Informal document **GRE-70-38**
(70th GRE, 21-23 October 2013,
agenda item 14(c))

UN Regulation No. 4 on Rear Registration Plate Lamps

Proposal for Amendment of R4

Plate Sizes Uncovered by R4

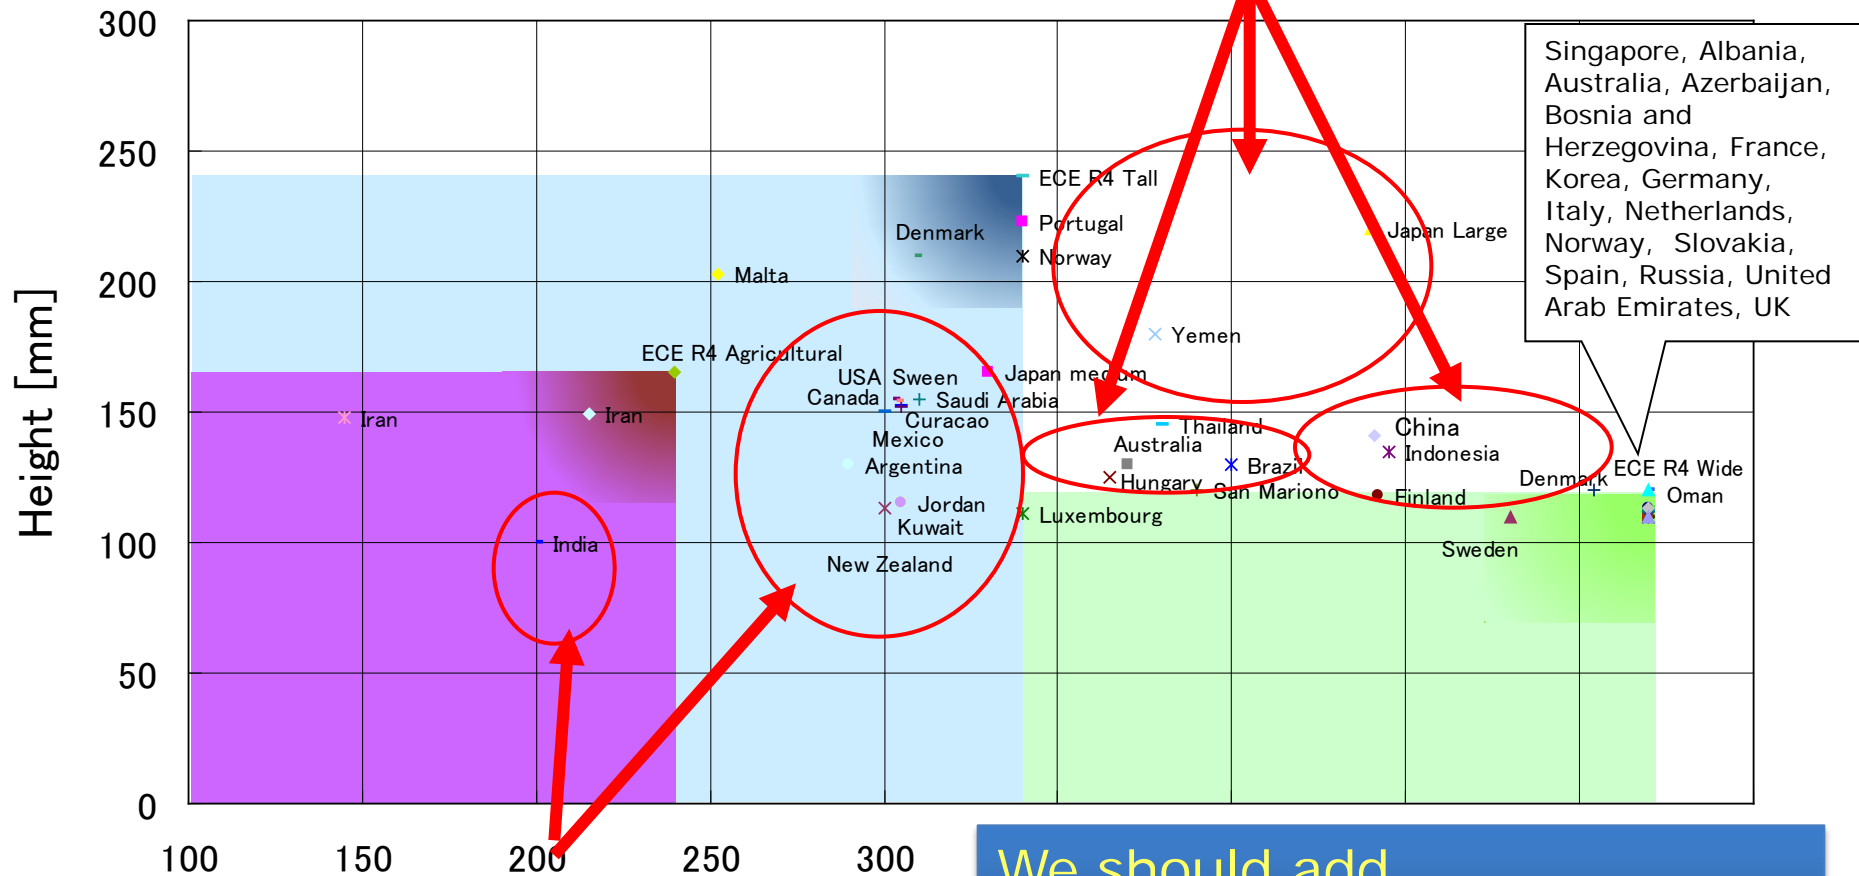
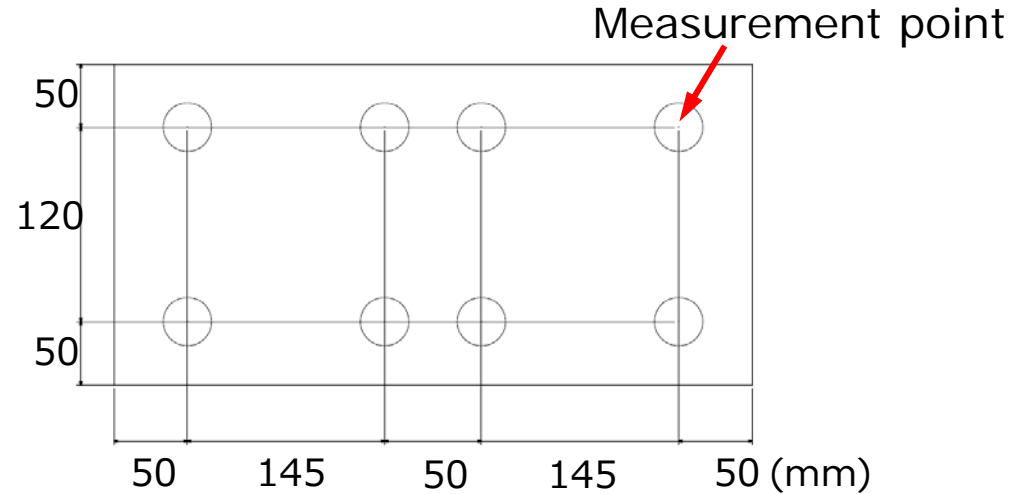
(i) These plate sizes are not covered by R4.

(ii) These plate sizes are quite different from the size of illuminated area in R4.

We should add some new illuminated areas?

To address the problem (i),

Add New Area (category), that covers Japanese Large Plates as well as other countries

(440 mm × 220 mm)

To address the problem (ii),

Add New Area (category), that covers Japanese Medium Plates as well as other countries

(330 mm × 165 mm)

Plate Sizes Covered by the current R4 and Japan's proposal

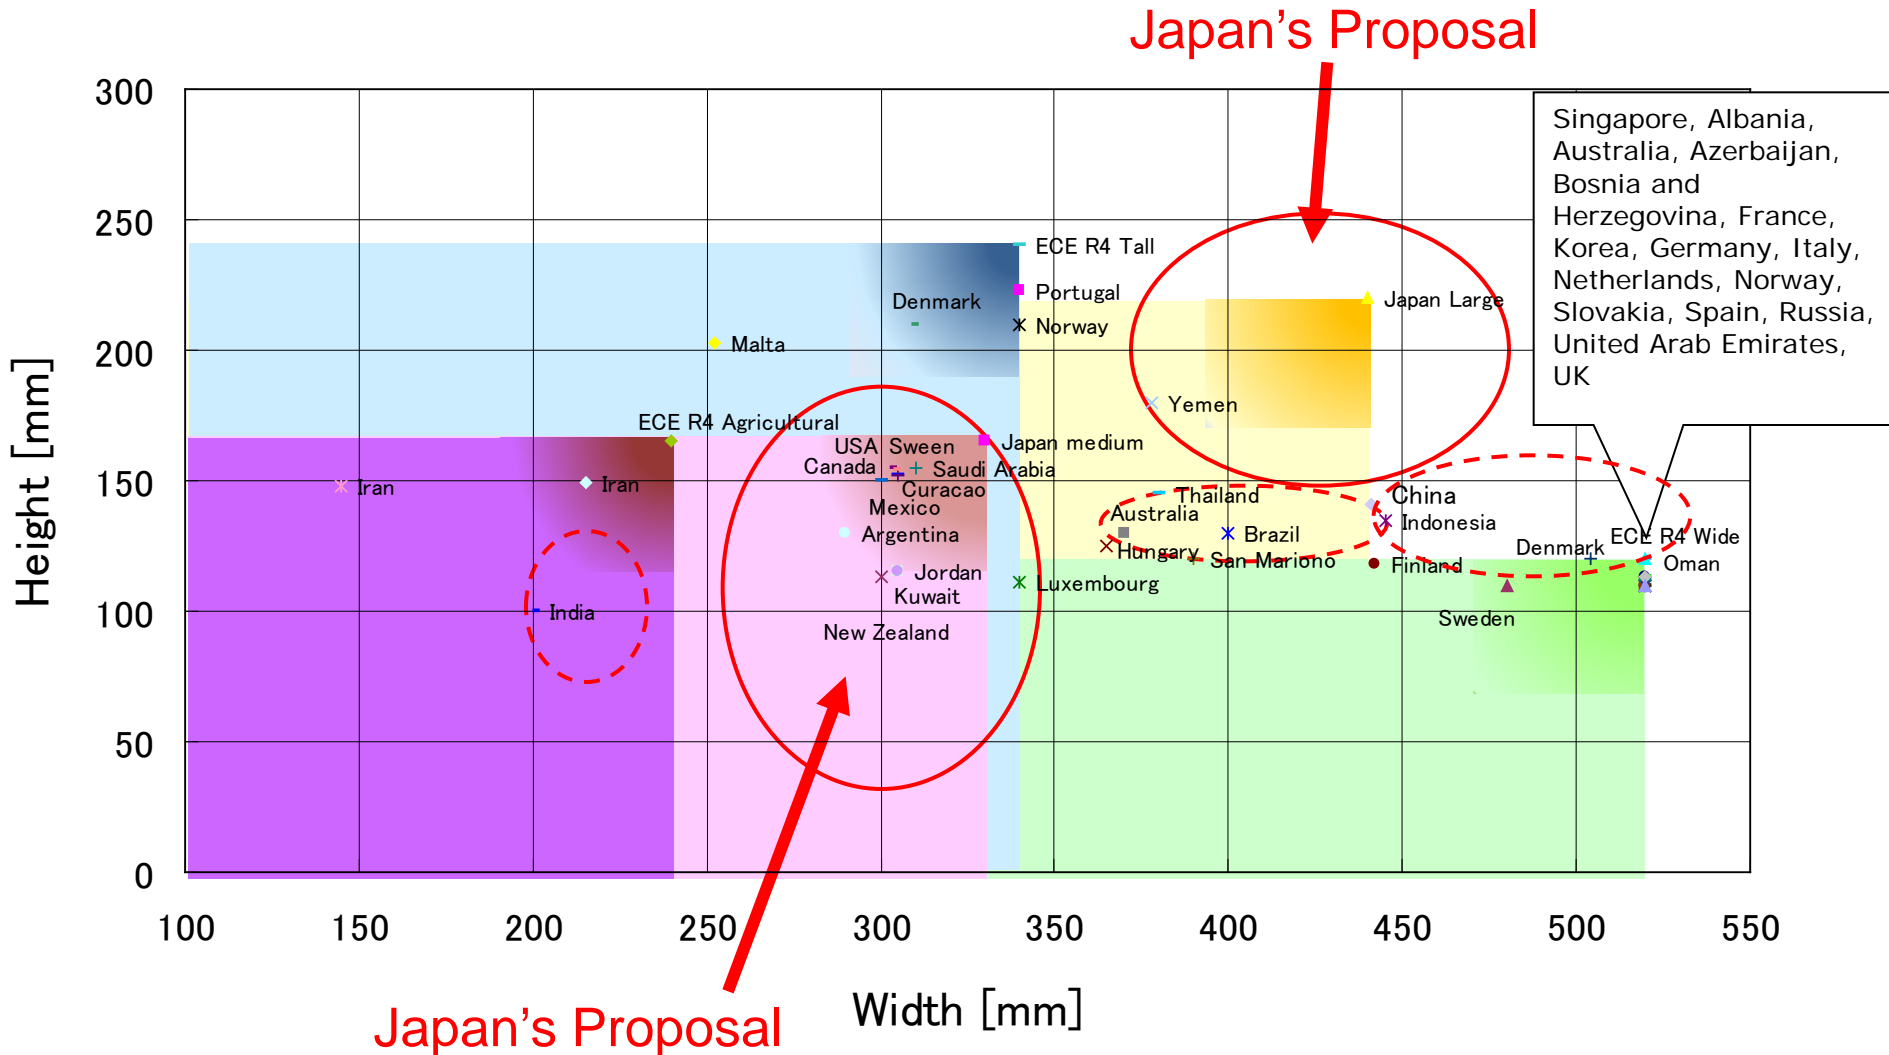
- Registration plate lamps covering new illuminated areas are added
 - Category 1a: For use to illuminate a registration plate, the size of which is 340 x 240 mm or less (tall plate).
 - Category 1b: For use to illuminate registration plate, the size of which is 520 x 120 mm or less (wide plate).
 - Category 1c: For use to illuminate registration plate, the size of which is 240 x 165 mm or less (plate for agricultural or forestry tractors).
- NEW**
- Category 2a: For use to illuminate registration plate, the size of which is 330 x 165 mm or less.
 - Category 2b: For use to illuminate registration plate, the size of which is 440 x 220 mm or less.“
